Land North of Barkby Road, Syston
Response to Leicestershire County Council Highways
Comments 27th January 2023

1.2.1 This note has been produced in response to additional comments raised by LCC in their response of 27th January 2023 and discussions at a meeting held on 16th March 2023.

Planning Application Number: P/21/2639/2

JOB TITLE		CLIENT	
Syston		Taylor Wimpey	
DRAWING TITLE			
Potential Future Roudabout Access Tracking			
SCALE	DRAWN BY	DATE	DRAWING No
1/500@A3	BP	09-02-23	20060-06-2
REVISION			
			a

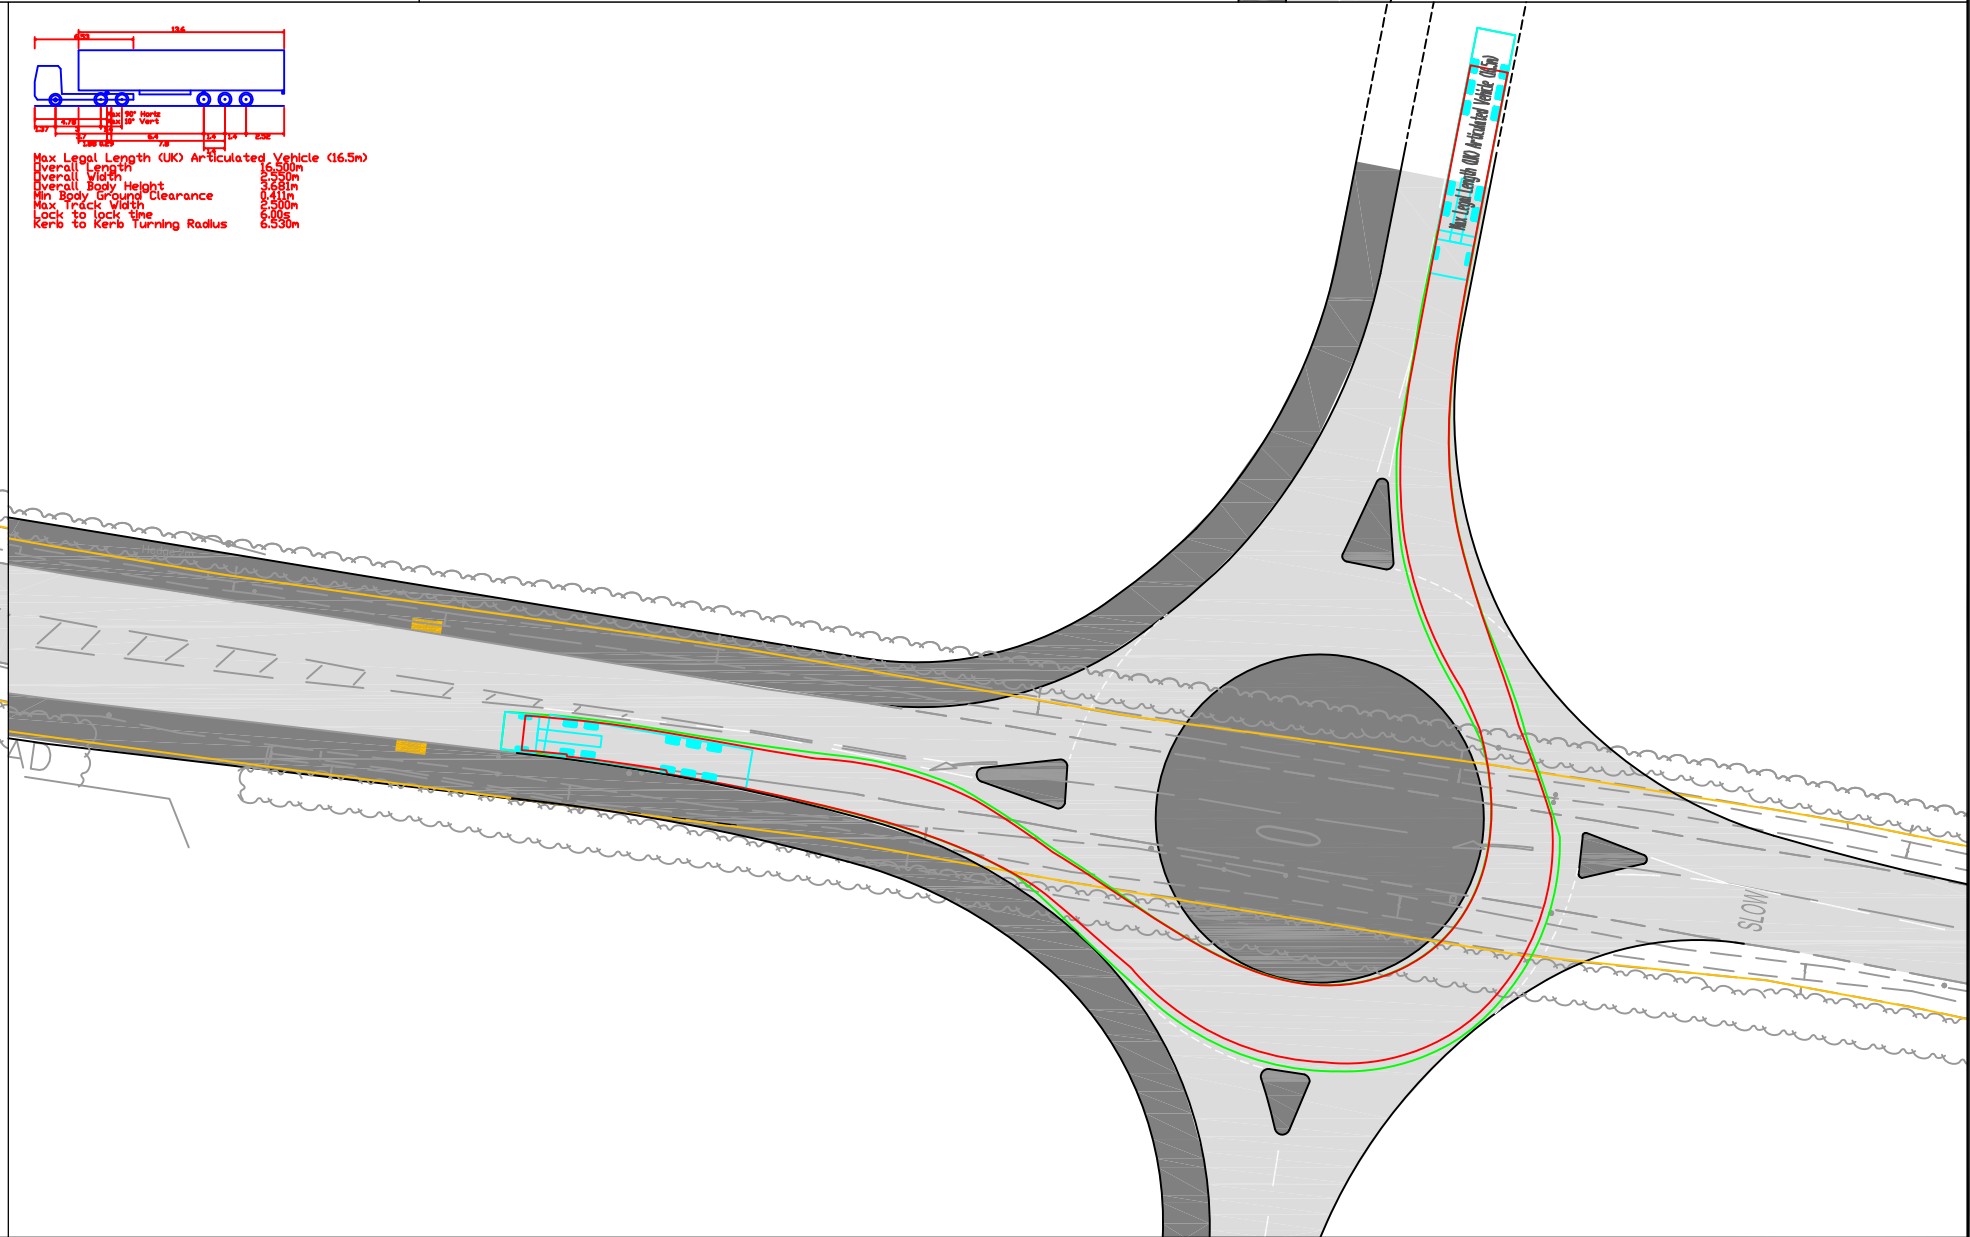
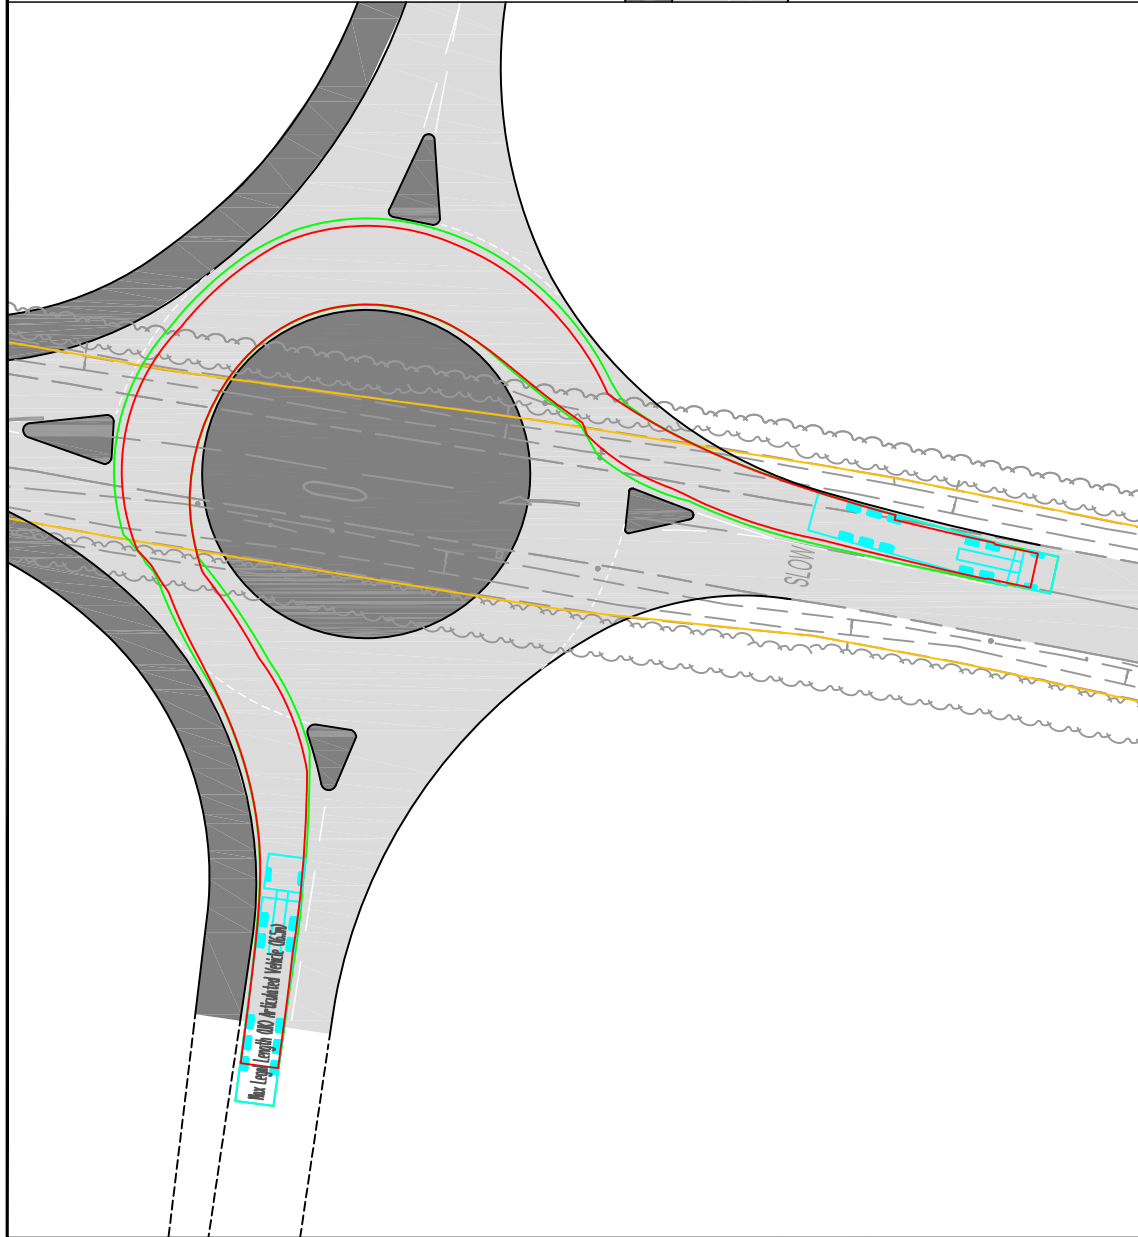
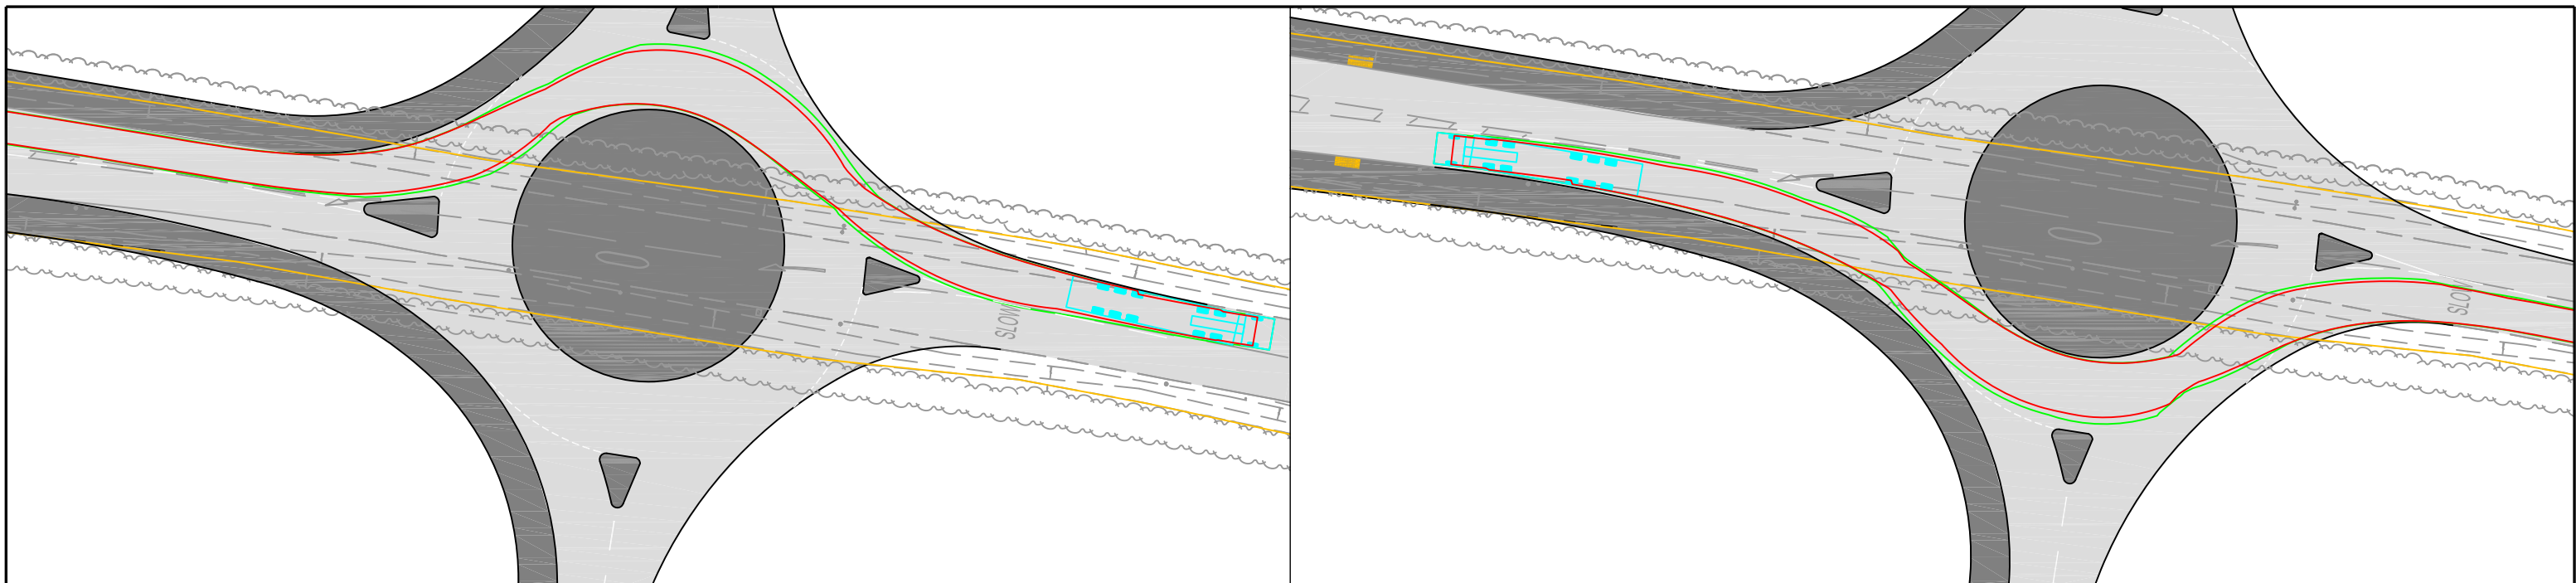
The tracking shown indicates that the design vehicle would overrun the proposed kerb-lines at a number of locations, and so the design layout should be amended to avoid this. The vehicle tracking would need to be resubmitted using a 15kph vehicle speed and indicating a 0.5m clearance to kerb-lines.

There is also concern that on both Barkby Road approaches to the roundabout, the design vehicle is also shown as conflicting with opposing traffic exiting the junction. The design layout must be amended to avoid this.

As mentioned earlier, the tracking for a vehicle on the circulatory carriageway suggests that a central overrun area may not be required and this should be avoided if possible. However, this would be subject to revisiting the tracking once the other concerns raised above have been addressed.

The comments raised by LCC relate to detailed design matters (circulatory widths, entry path curvature and tracking). These are all matters which can be addressed as part of the future planning application for the land south of Barkby Road but for completeness the details are provided on **Drawing 20060-06 Rev A and 20060-06-2A**.
